Docket Number:	15-AFC-01
Project Title:	Puente Power Project
TN #:	218873-1
Document Title:	Supplemental Testimony of Dr. Revell
Description:	N/A
Filer:	PATRICIA LARKIN
Organization:	Revell Coastal
Submitter Role:	Intervenor Representative
Submission Date:	6/15/2017 3:00:55 PM
Docketed Date:	6/15/2017

Supplemental Testimony of Dr. David Revell

Subject: Supplemental Testimony on the Proposed Puente Power Plant

Figure 1. Maximum Wave Run-up versus Dynamic Wave Setup (excerpted and revised from FEMA guidelines)

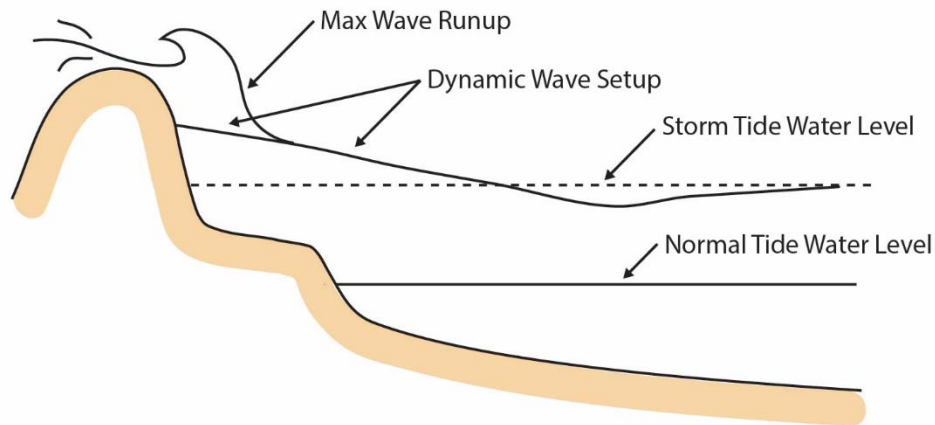
In contrast, the USGS COSMOS utilizes a composite of downscaled global climate model storms to evaluate potential inundation. This approach excludes historic data of local storm events. Instead, it uses dynamic wave setup water level flood surface with a 1-2 minute inundation frequency (Figures 1, 2). Dynamic wave set up is the essentially static water level that is sustained for at least 2 minutes due to a series of waves breaking at the coast. Wave run up is the maximum height that the waves reach when they break on the shore and rush up the beach.

- Third, COSMOS 3.0 maps coastal flood hazard zones associated with dynamic wave set up and sustained 1-2 minute flooding and NOT maximum wave run up (Figure 1), which is typically used in regulatory coastal flood hazards mapping. Using dynamic wave setup instead of maximum wave run up can often understate inundation results by more than 6 feet.

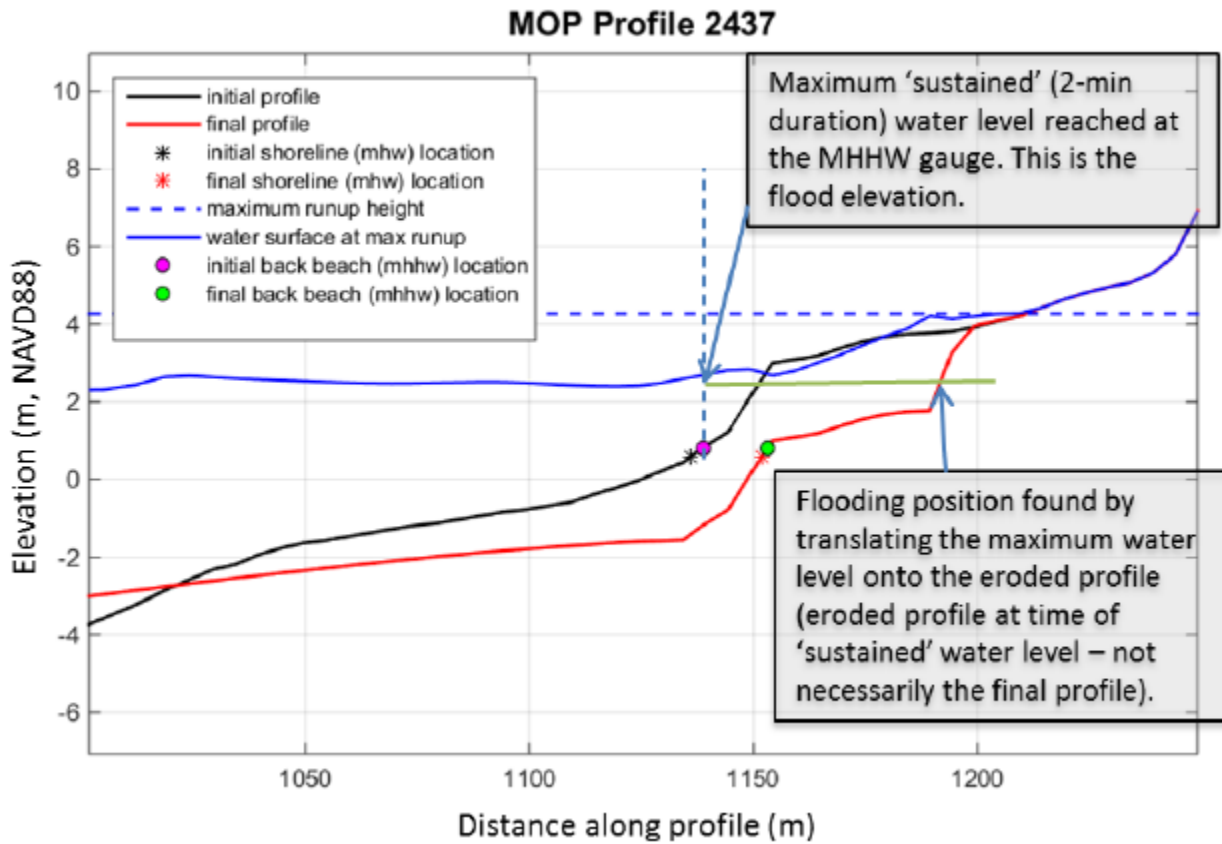
The difference between these two reference flood elevations to modeling flood hazards can be up to 6.5 feet (~2m) in water level, Barnard et al 2017, (Figure 2).

Figure 3. Excerpt from the FEMA Pacific Coast Flood guidelines for Beach/Dune Coastal Setting (NHC 2005).

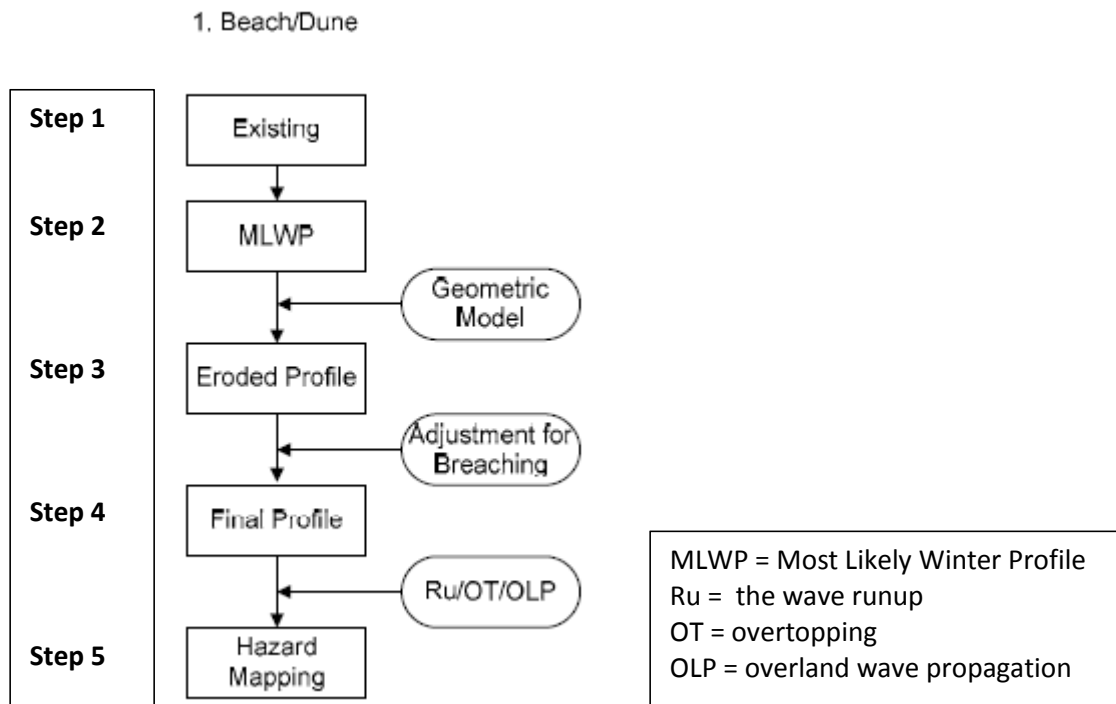
The FEMA guidelines methodology shown in Figure 3 is based on the backshore setting which in the case of the proposed Puente Plant is a Beach/Dune. Technical review and analysis were conducted based on the the preliminary FIRM maps and Interim Data Submittals (IDS) created by the FEMA contractor Michael Baker/AECOM.

Based on the technical review, overall, the application of the FEMA methodology to Beach and Dune coastal settings was not fully applied by the FEMA contractor. Specifically Steps 2, 3, and 4 were not applied to this site. As a results, the

Figure 4. FEMA PFIRM escalated with sea level rise (excerpt from testimony submitted on January 18, 2017 TN #215427)

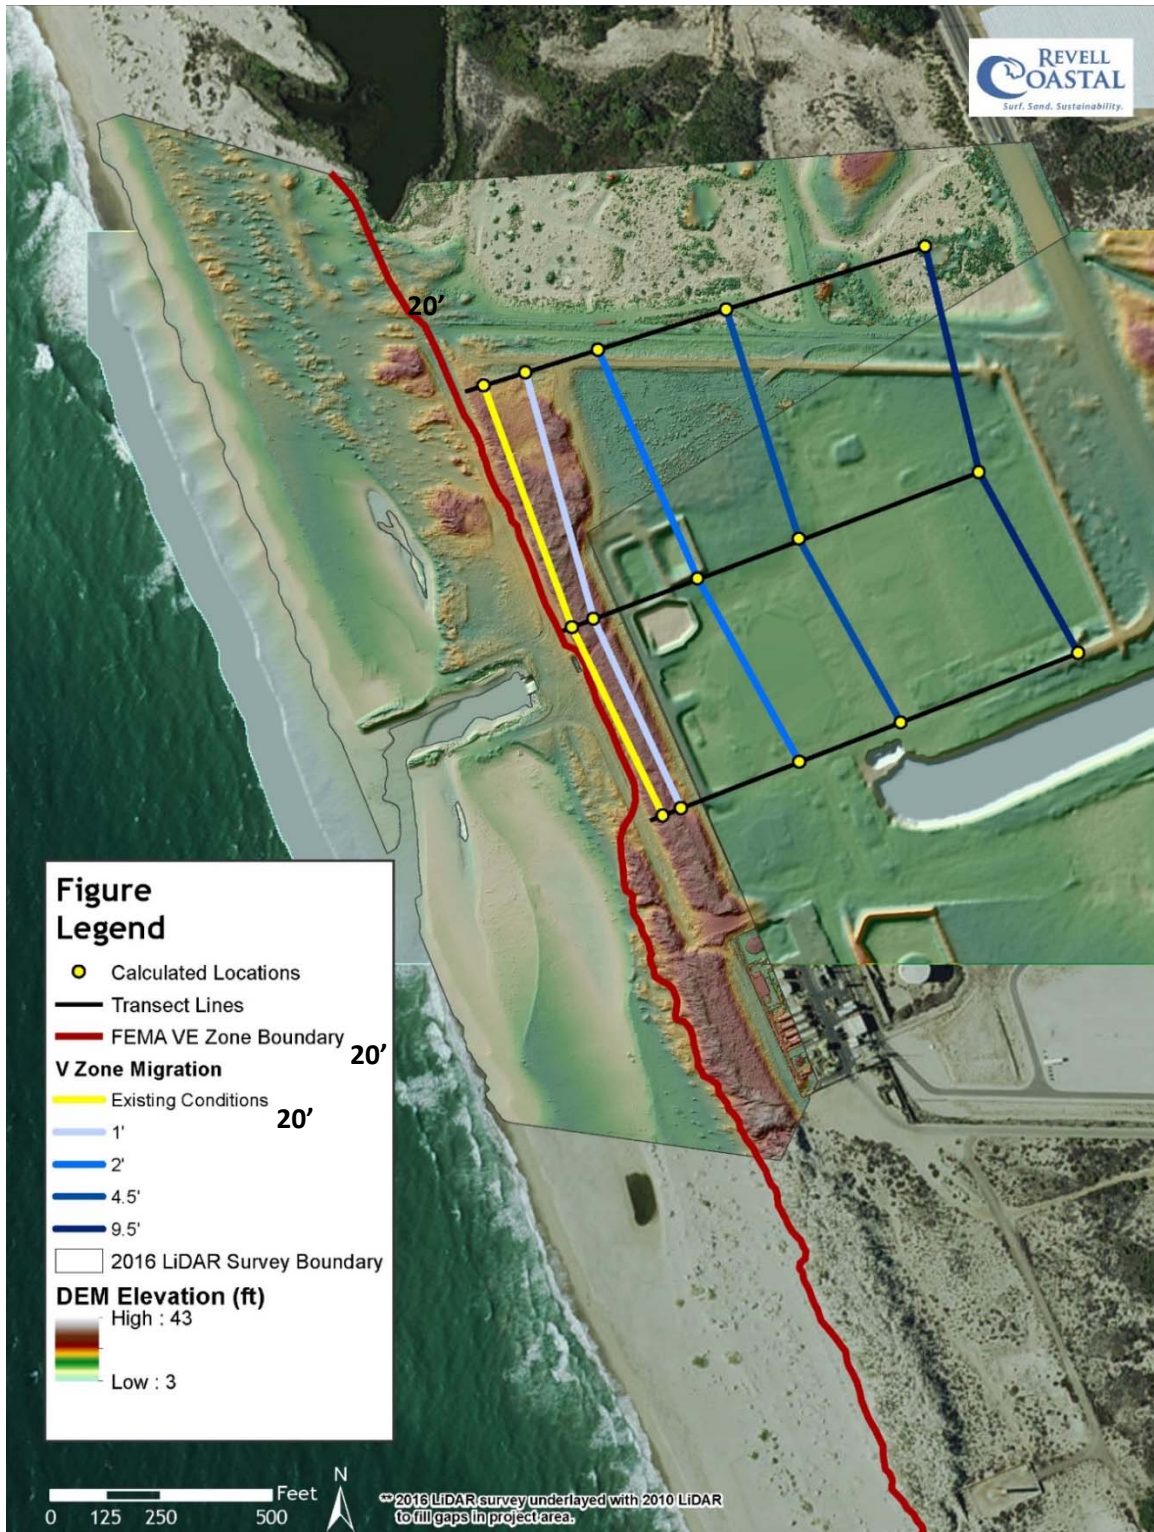
The FEMA FIRM maps only map existing flood hazards. These maps do not consider sea level rise. To evaluate the effect of sea level rise on existing flood hazards, it is insufficient to simply add sea level rise to the base flood elevation since wave run up dynamics change with different water surface elevation. In order to provide guidance on how to evaluate sea level rise induced changes to the FEMA FIRM maps, the California Department of Water Resources commissioned a study which resulted in a technical methods manual to escalate FEMA maps with sea level rise (see testimony submitted on January 18, 2017 TN #215427). The City followed this methodology and the results are shown in Figure 4.

As can clearly be seen in Figure 4, using 2 feet of sea level rise shows that the proposed power plant site would be exposed to high velocity coastal flooding.
